**MUNICIPAL SERVICES CENTER, COUNCIL CHAMBER
3600 TREMONT ROAD**

BZAP Meeting Date: May 3, 2023

Subject: 2231 Inchcliff Drive (VAR-17-23) - To allow a two-story addition encroach up to five feet into the 10-foot minimum rear yard setback and up to 7'-5" into the rear yard profile limit.

BZAP Staff Report Pictures

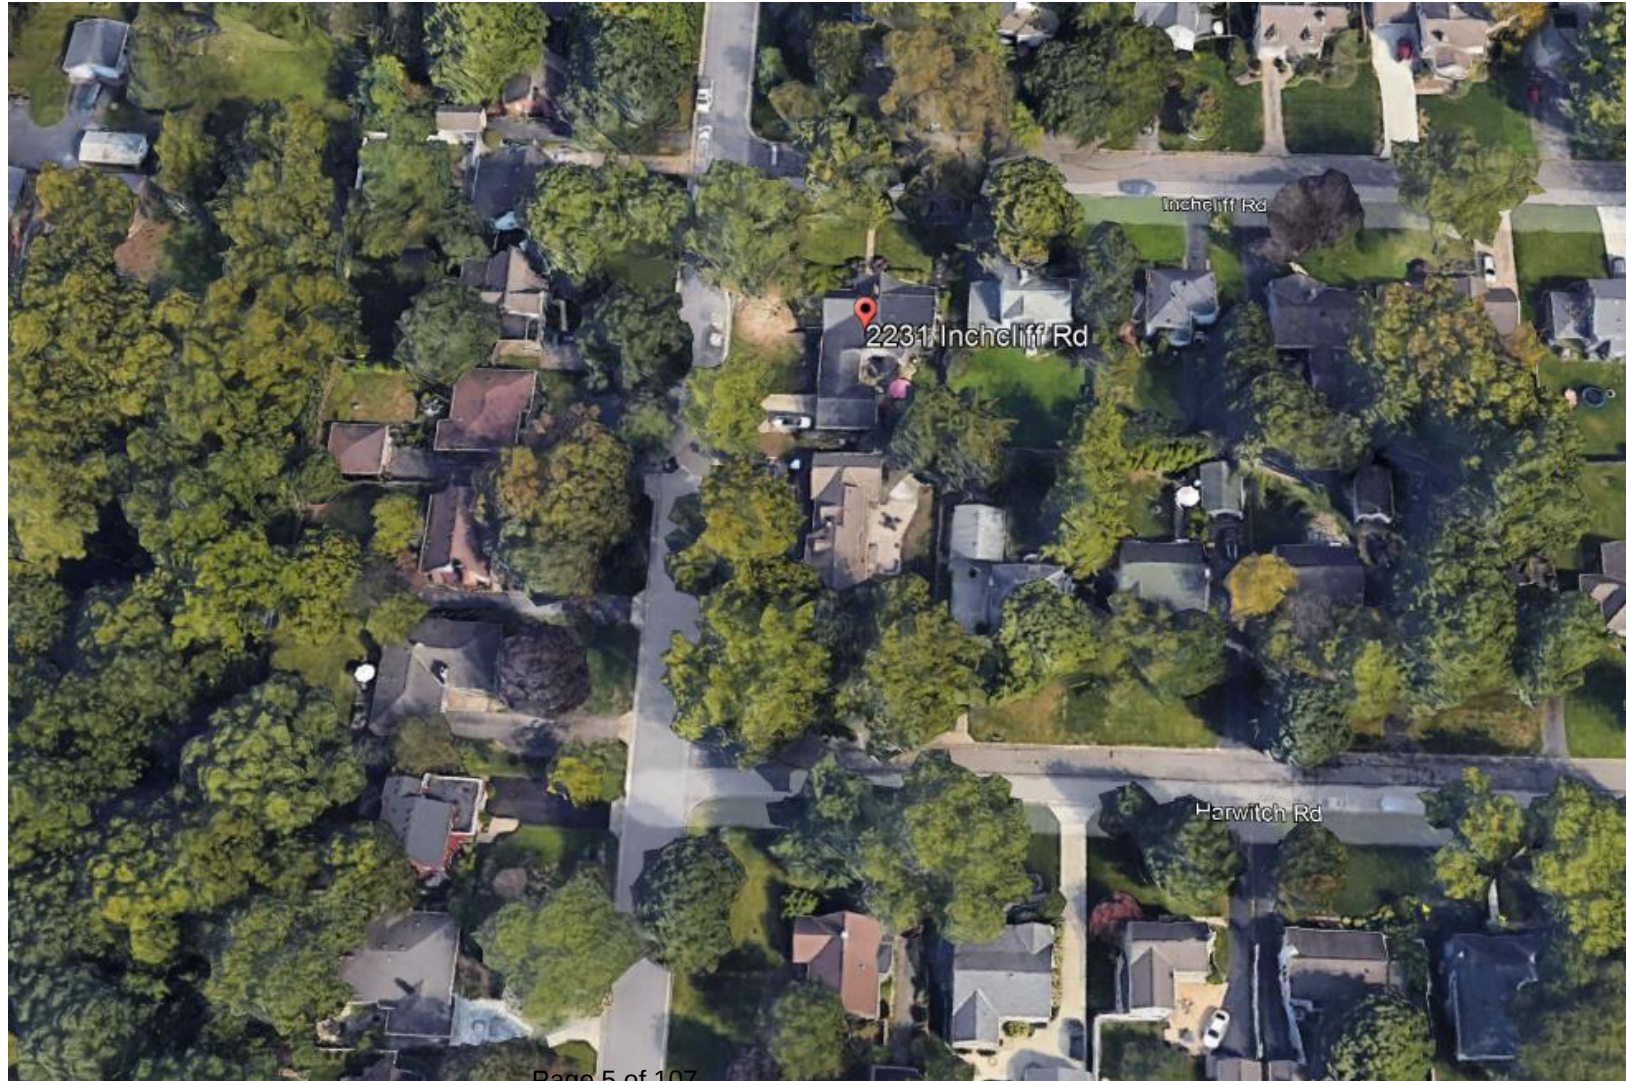
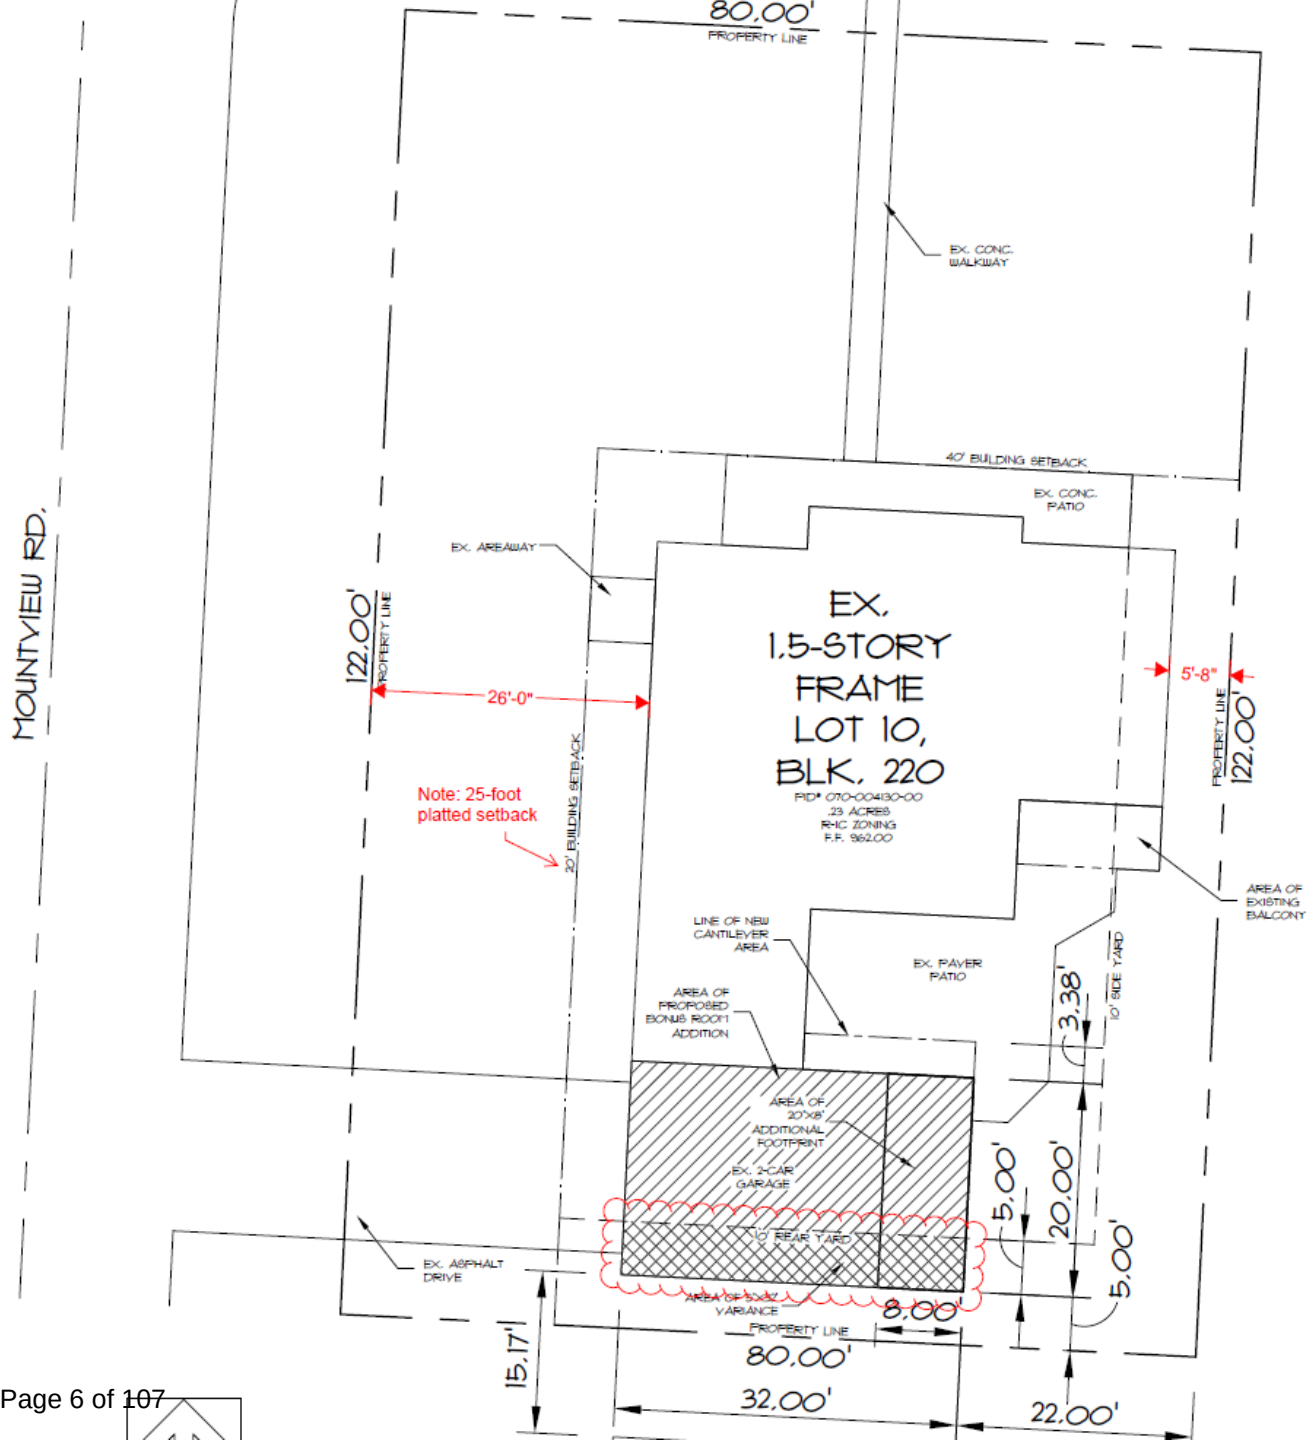
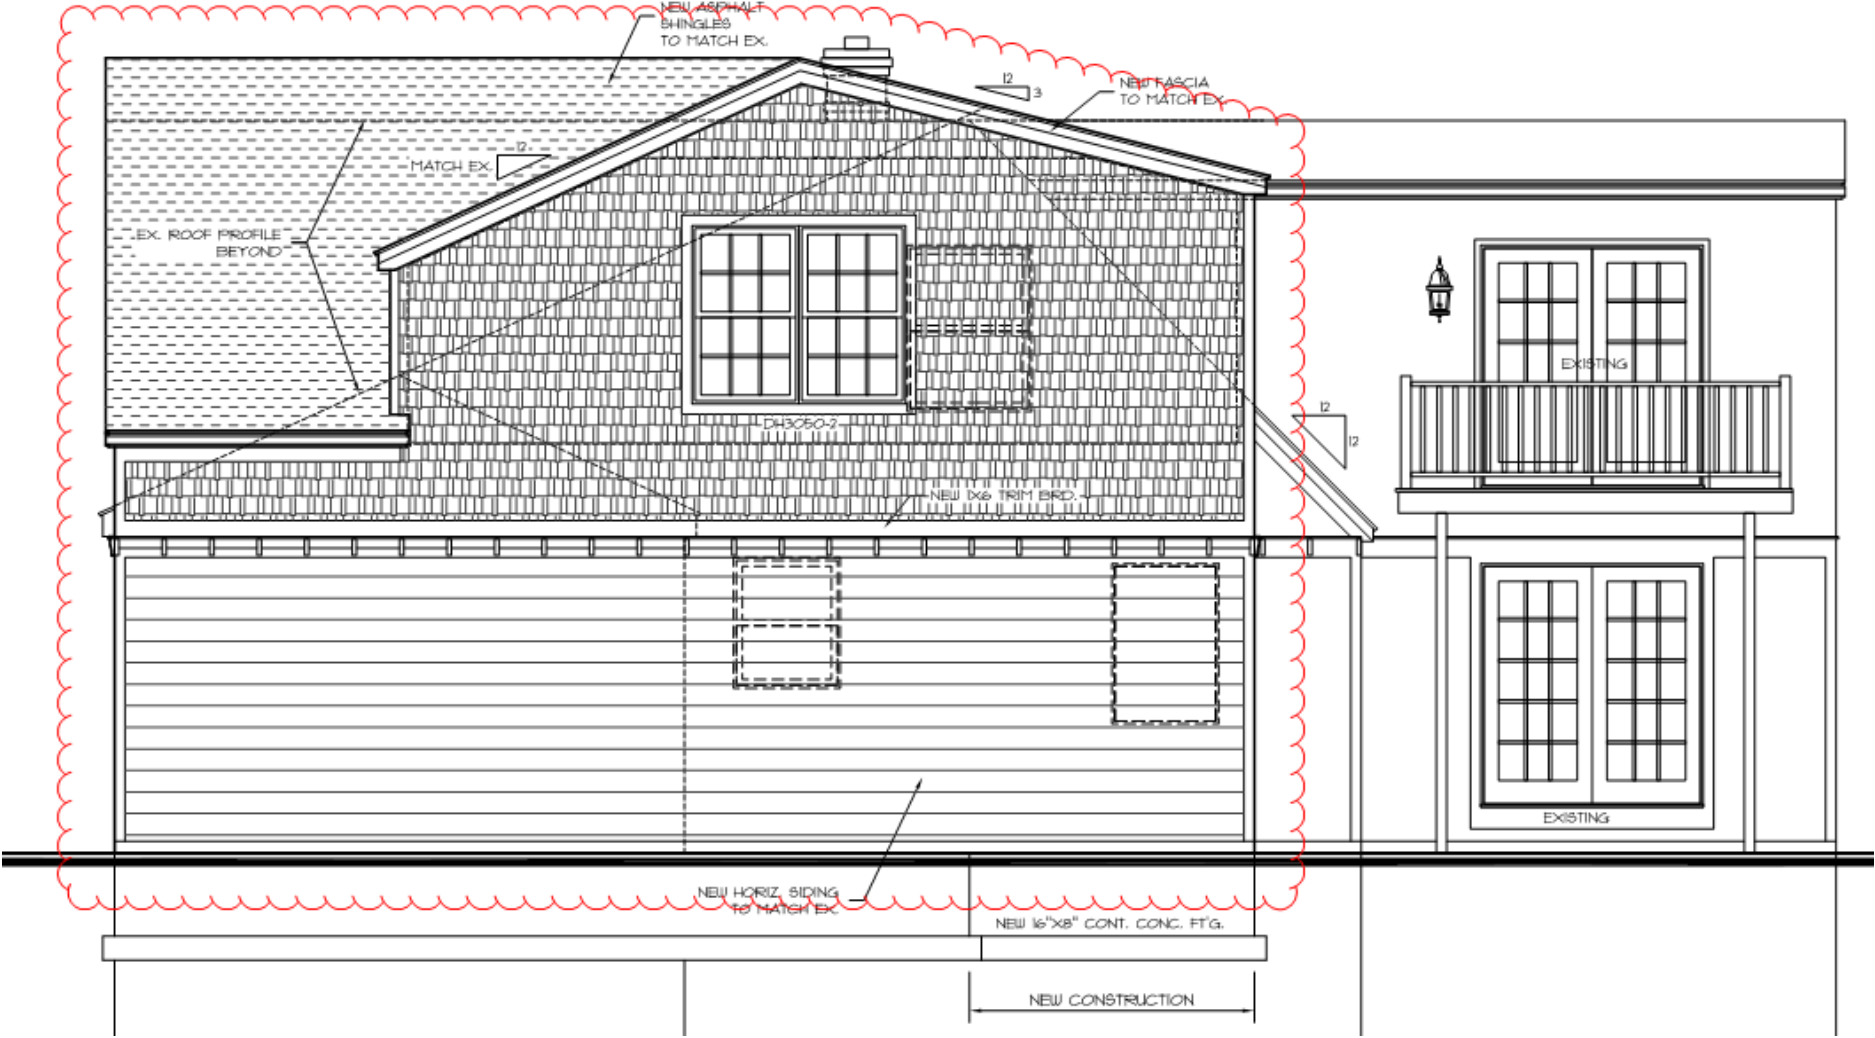
Staff has reviewed the application, discussed with the applicant, and visited the site. Although Staff understands the desire for additional storage and living space, the proposed plan would place a two-story addition just five feet from the rear property line, which would result in looming impacts on neighboring properties. While there have been variances granted for rear yard setbacks and rear yard profile requirements in the neighborhood, including directly south of this property, the resulting encroachments were not as extensive. Staff has also received concerns from a neighbor who was notified.

Therefore, Staff cannot recommend approval of this application at this time and would recommend the applicant consider alternative options including re-orienting the second-story addition away from the rear property line, reducing the height and massing of the addition, and eliminating the two side-facing portions of the addition. The Board may consider Finding #4 during deliberations.
